Bid Addendum

Addendum No. 1 for Augusta Water Middle River Regional WWTP Secondary Clarifier No. 3 Grout Topping Replacement, Wiley|Wilson Comm. No. 222110.10.

Addendum Date: February 6, 2024
To: All Bidding Contractors
From: Wiley|Wilson
Lynchburg, VA

PROJECT NO.
142230MR
C-01
 SHEET
 8 OF 141

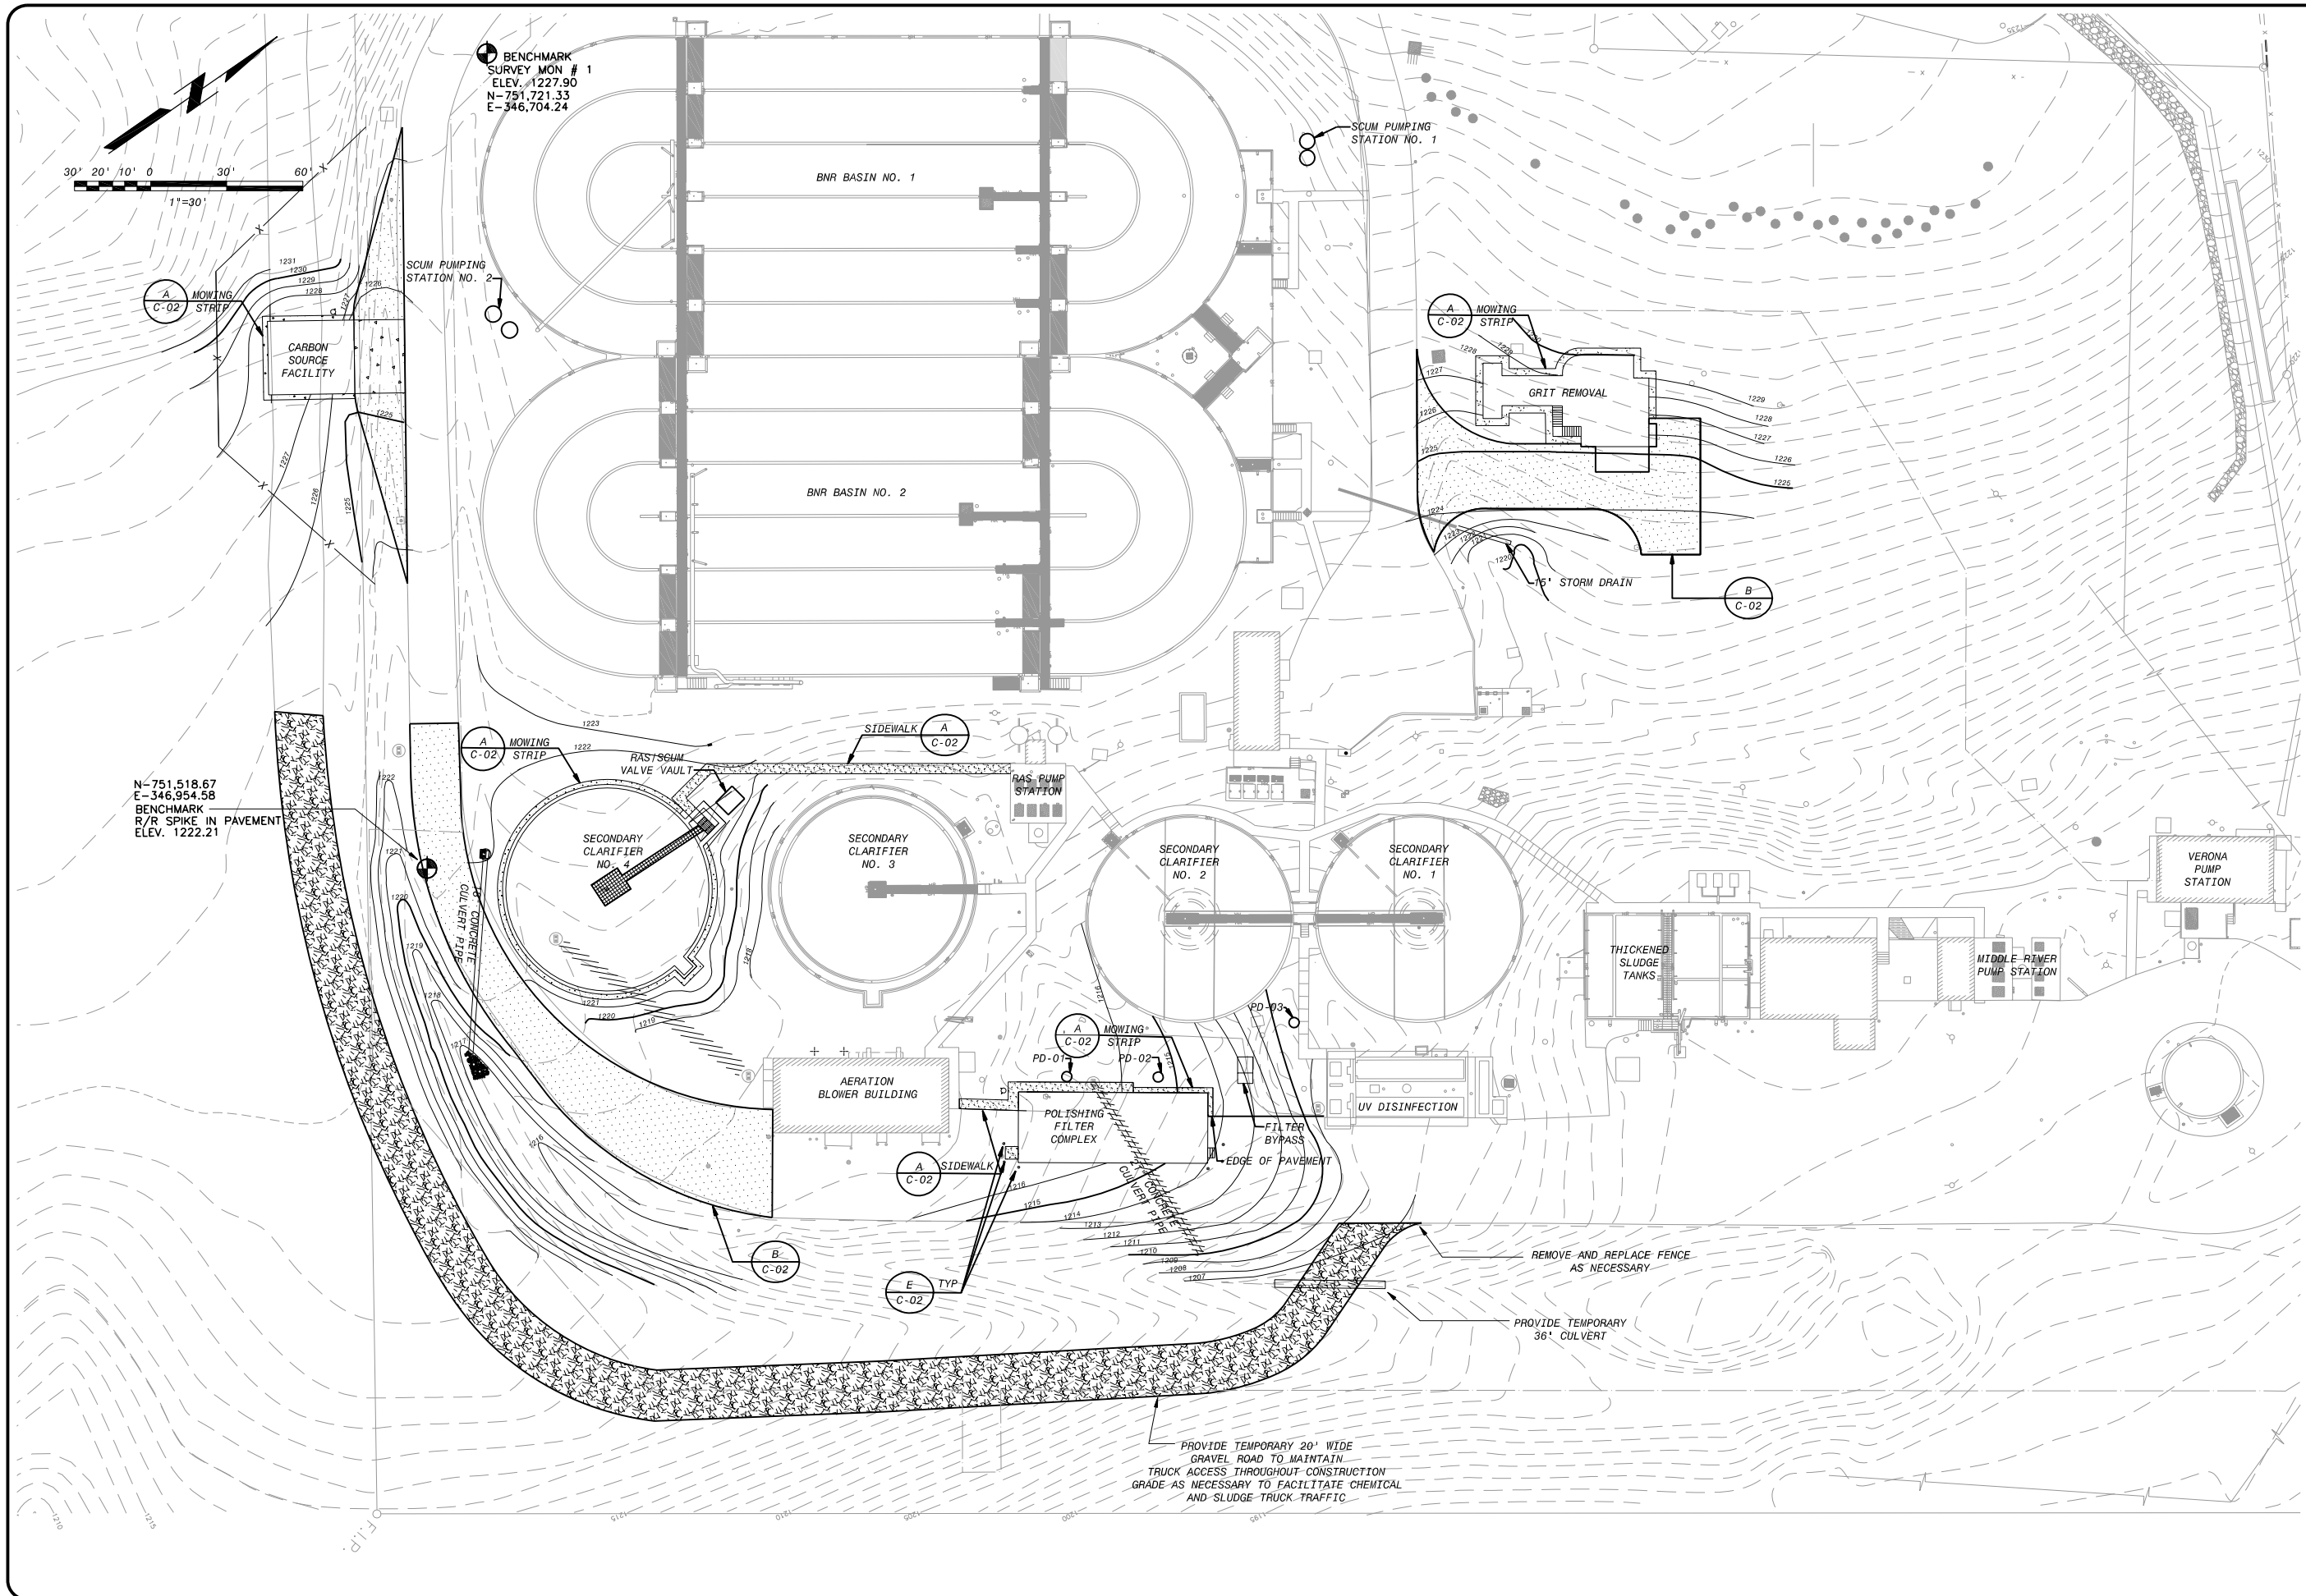
Question 11: Can Vac Truck access 360 Deg of sidewalk?

Question 12: Is there a laydown area that could be turned into a dump pit for hydro demo heavy aggregate picked up with vac truck?

Question 14: Where can hydro demo slurry water be pumped? How far is the run?

Response: Refer to attached C-01 record drawing site plan. Access is approximately limited to 270 degrees.

Response: Laydown areas are available on the plant site and adjacent areas outside the plant

Response: Slurry water may be pumped to the plant influent pump stations (Verona or Middle River Pump Station) or Grit Removal if it contains grit or the RAS pump station. Refer to attached C-01 plant site plan. Hydro demo slurry water **must** conform the AW's Rules and Regulations for Wastewater Discharge including local limits available at <https://www.augustawater.com/standards>.
